**From:** Laura Probus <lprobus@ht-school.org>  
**Sent:** Monday, October 4, 2021 11:22 AM  
**To:** St. Germain, Dante  
**Subject:** 21-zone-0013

**From:** Sheri Lamothe <shlamothe@gmail.com>  
**Sent:** Monday, July 12, 2021 1:11 PM  
**To:** St. Germain, Dante; Jon Bingham-Eastland Church Of Christ  
**Subject:** Re: 21-ZONE-0013 Plan comments

**From:** John Adams <jeadams60@gmail.com>  
**Sent:** Wednesday, May 26, 2021 12:44 PM  
**To:** St. Germain, Dante  
**Subject:** Traffic issue Case #21-Zone-0013  
**Attachments:** Map of issue.png; Road IMG-0804.MOV; Road 1.jpg

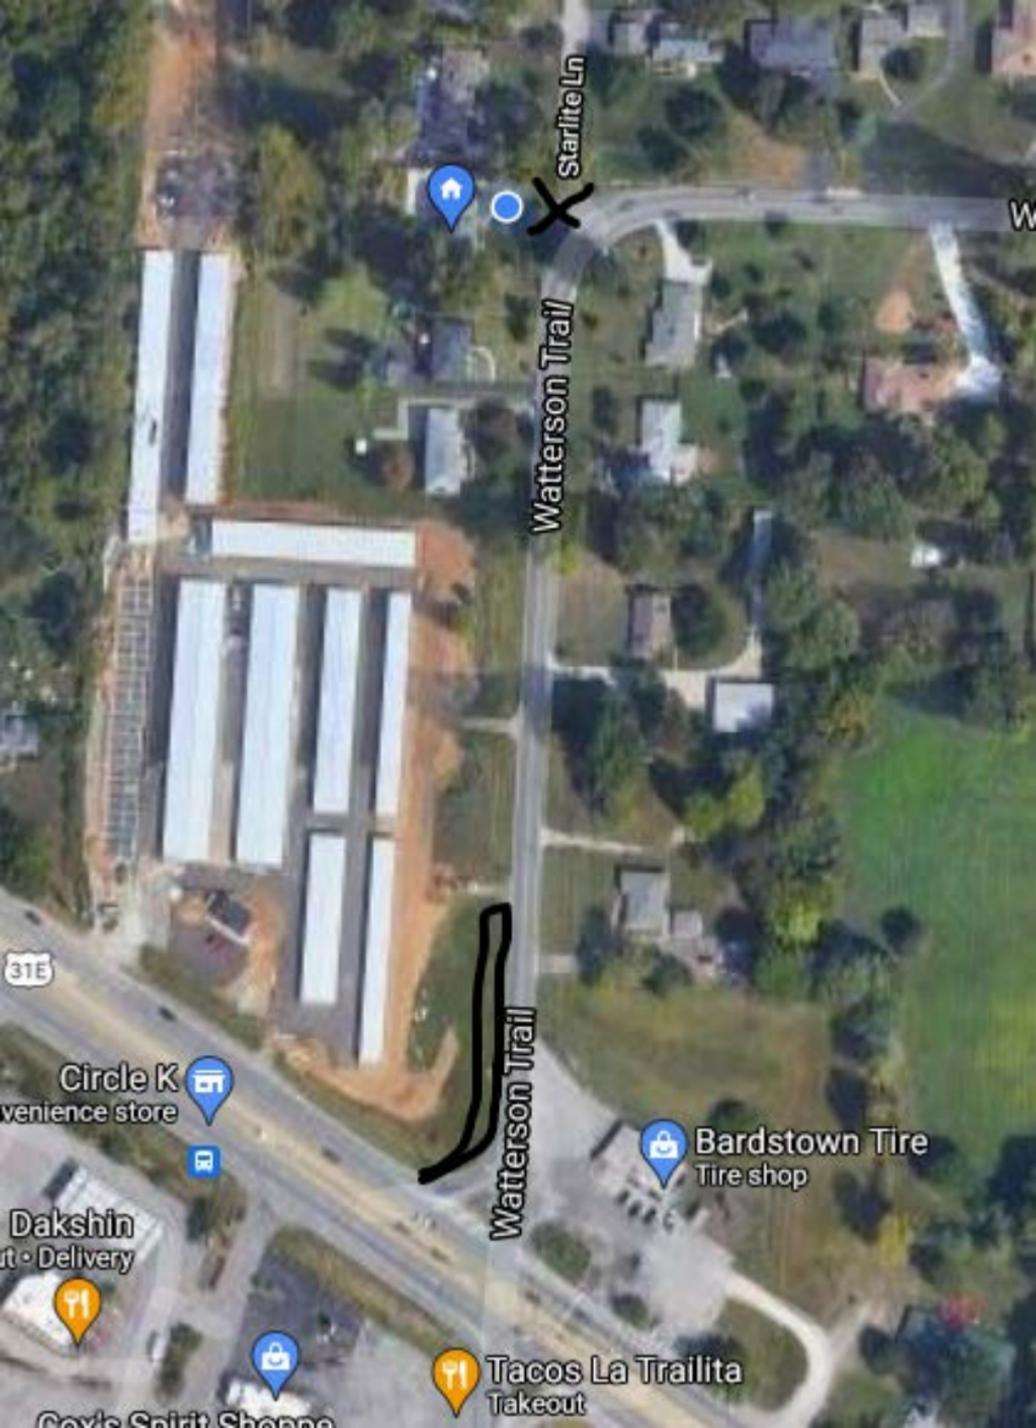
My name is John Adams, 8011 Watterson Trail, Louisville, KY 40291. Please help us with an existing issue that will get worse if the apartments are build on the corner of Bardstown Road and Watterson Trail.

We have a backup several times a day from the intersection past Starlight Lane. In light of the Stan Simms project to build apartments on that corner, we need an extra lane to relieve the traffic. Even if that project doesnt go through, we still need a turning lane.

1. A map of the corner. The X shows where the video was taken. I drew a lane that needs to be added to the corner.
2. A Video of the issue
3. A picture showing the backup on Watterson Trail towards J-town.
